The Greater Cambridge Design Review Panel

**16-17 and 18-19 Sidney Street and 21 Hobson Street, Cambridge
(22/50409/PREAPP)**

23rd March 2023

Proposed Ground Floor Plan

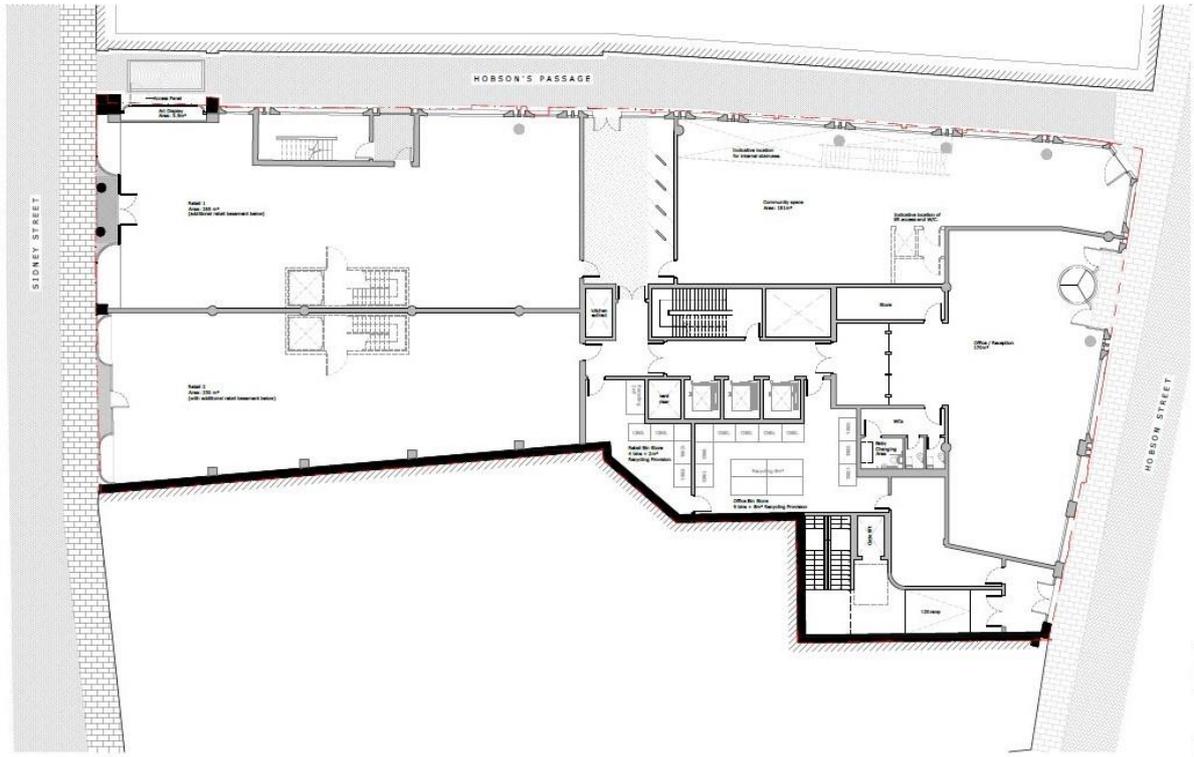
The Panel notes the separate cycle parking areas for the community space and the offices, with access from Hobson's Passage for the former, and Hobson Street for the latter. Exceeding BREEAM cycle parking standards by providing more than 150 spaces so that visitors can use them too is a clear benefit; providing a cycle repair area, a cycle lift and gulley on the basement stairs are all endorsed features but the access routes themselves need to be checked, to ensure that larger bikes can be manoeuvred.

The Panel does however suggest that the design team should consider flipping the accesses to the bin store and office cycle parking, so that the office entrance is not adjacent to the bin store access. It would be more appropriate for the office cycle parking access to be adjacent to the office entrance; the office employees arriving by bike seem to be underserved, when compared with the space provided in the office lobby area - the two elements are not in quite the right balance at present.

While electric scooter charging has been mentioned, the Panel notes that the design team has yet to consider the same for cycles; overall, efforts should be made to maximise the number of charging points in all of the cycle/ scooter storage areas.

In looking at the refuse strategy, the Panel recommends reassessing the design/ width of the corridor that is the same route as for cycles -there is a potential contamination issue with the current arrangements. A refuse collection strategy is needed, one that make clear where bins will be put on Hobson Street.

The community space should also be able to use the retail bins store.

The narrow pavement on Hobson Street and the position of the bus stop leads the Panel to conclude that there is a clear need to assess current and future pedestrian footfall and the volumes of bus stop users. The footway is potentially heavily used by both; consideration therefore needs to be given as to how these users will interact with the proposed office building's activities. The results of this assessment should assist in potentially revisiting the building line of the review scheme, whether that is to look at setting the building back along part of its length to make space for a bus shelter on a wider footway, or introducing a setback of just one metre at its north eastern corner to open up the walking route into/ out of Hobsons Passage, perhaps even allowing the planting of a tree here.
